# UNITED STATES PATENT AND TRADEMARK OFFICE

APPLICATION NO.	FILING DATE	FIRST NAMED INVENTOR	ATTORNEY DOCKET NO.	CONFIRMATION NO.
10/684,684	10/15/2003	Kohei Yamanaka	Q76899	3402

**Office Action Summary**

### **DETAILED ACTION**

Smith et al., 3,688,521.

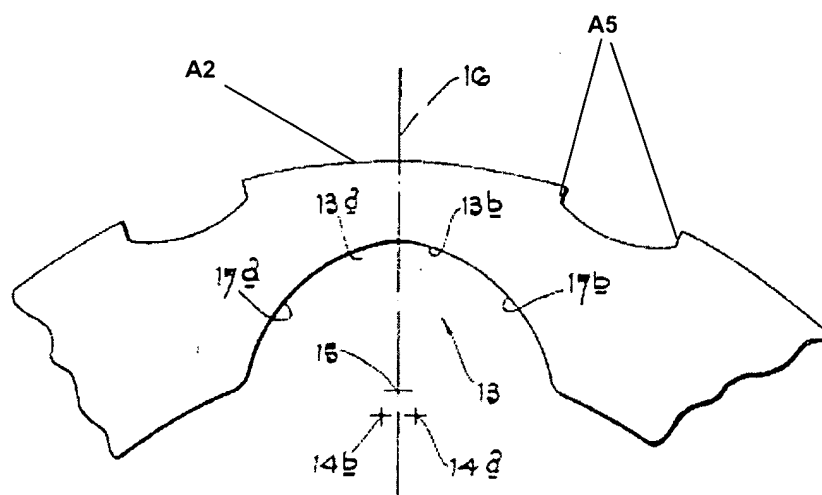
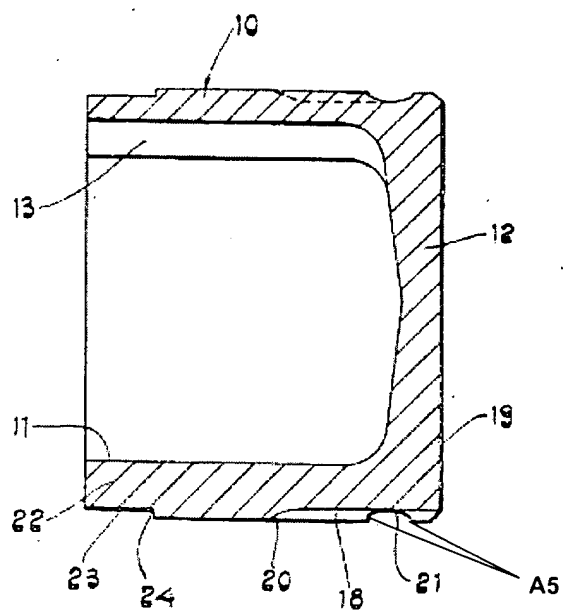
Regarding claim 1, Smith et al. discloses, in Figure 1-4, a structure comprising a shaft member **26** and a cylindrical member **25**. The shaft member **26** is formed out of a first material. The shaft member **26** has an outer periphery **A2** formed with an axial groove **18** and a circumferential groove **21**. The axial groove **18** and the circumferential groove **21** have a cross-section having opposed faces **A5** substantially parallel to each other. The cylindrical member **25** is fitted to the outer periphery **A2** of the shaft member **26**. A caulked portion **18** is provided to the cylindrical member **25** at an intersection of the axial groove 18 and the circumferential groove 21 (col. 3, lines 19-24; Figure 4 shows an intersection). The caulked portion **18** has a deformed inner surface **A8** in press contact with the faces **A5** of the circumferential groove **21** and the caulked portion has a deformed inner surface in press contact with the opposed faces of the axial groove (col. 3, lines 19-24). However, Smith et al. do not disclose the cylindrical member **25** being formed out of a second material greater in linear expansion coefficient than the first material.

Regarding claim 6, the axial groove **18** comprises a plurality of groove portions in a circumferential direction.

Regarding claim 7, the groove portions are three in number.

Regarding claim 9, the cylindrical member **25** is loosely fitted to the shaft member **26** except the caulked portion **18**. Applicants should note that anywhere there is not a caulked portion there is no connection and thus the cylindrical member is loosely fitted to the shaft member as well.

Regarding claim 8, Smith et al., as discussed, fails to disclose the axial groove **18** and the circumferential groove **21** being rectangular. Applicants are reminded that a change in the shape of a prior art device is a design consideration within the skill of the art. In re Dailey, 357 F.2d 669, 149 USPQ 47 (CCPA 1966). Therefore, it would have been obvious to one of ordinary skill in the art at the time the invention was made to design the groove of a rectangular cross section as taught by Fujioka et al., Fig. 8.

Regarding claim 10, Smith et al., as modified, fail to disclose the axial groove **18** having an opening edge formed at an acute angle. Edgemon, Jr. teaches, in Figure 2, an axial groove **18** having an opening edge formed at an acute angle. Edgemon, Jr. does not state why the opening edge is formed at an acute angle. Applicant is reminded that side faces of a rectangular axial groove formed on a cylindrical surface inherently form an opening edge at an acute angle as part of a design consideration. Therefore, as taught by Edgemon, Jr., it would have been obvious to one of ordinary

Regarding claim 2, Smith et al., as modified, fail to disclose the axial groove **18** and the circumferential groove **21** being different in depth from each other. Krude et al. teach, in Figure 5, an axial groove **11** and the circumferential groove **12** being different in depth from each other to receive portions of the material of the cylindrical member which will consist of a diameter reduction of the cylindrical member and the material volume displaced by tooth portions (col. 6, lines 11-18). Therefore, as taught by Krude et al., it would have been obvious to one of ordinary skill in the art at the time the invention was made to make the axial groove **18** and the circumferential groove **21** different in depth from each other to receive portions of the material of the cylindrical member consisting of a diameter reduction of the cylindrical member and material volume displaced by tooth portions between the axial grooves.

Regarding claim 5, given the modification, the caulked portion comprises a first caulked part corresponding to the circumferential groove **21** and a second caulked part corresponding to the axial groove **18**. The second caulked part would be arranged substantially in a middle of the first caulked part.

Regarding claim 3, Smith et al., as modified above, fail to disclose the axial groove **18** greater in depth than the circumferential groove **21**. Applicants are reminded that a mere reversal of the essential working parts of a device involves only routine skill in the art; therefore, it would have been obvious to one having ordinary skill in the art at the time the invention was made to make the groove with a greater depth than that of the circumferential groove or vice versa. *In re Einstein*, 8 USPQ 167. Further, See Jackman as Figures 3-4 teach an axial groove greater in depth than the circumferential groove.
